## **Addendum 29: Regulation No. 30**

### **Revision 3 – Amendment 3**

Supplement 17 to the 02 series of amendments - Date of entry into force: 27 January 2013

### **Uniform provisions concerning the approval of pneumatic tyres for motor vehicles and their trailers**

## "Annex 3

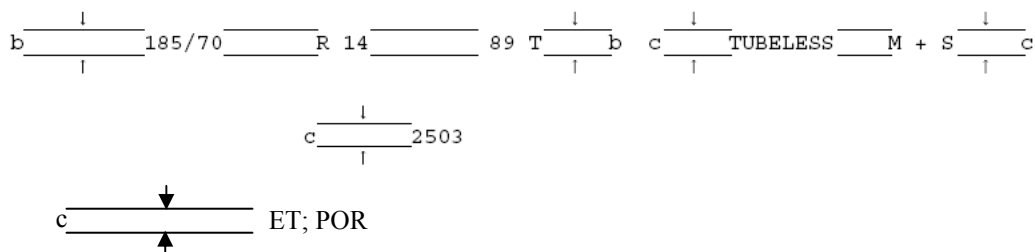
Paragraph 1., amend to read:

- "1. Example of the markings to be borne by type of tyres placed on the market after the entry into force of this Regulation

b = 6 mm (min.)
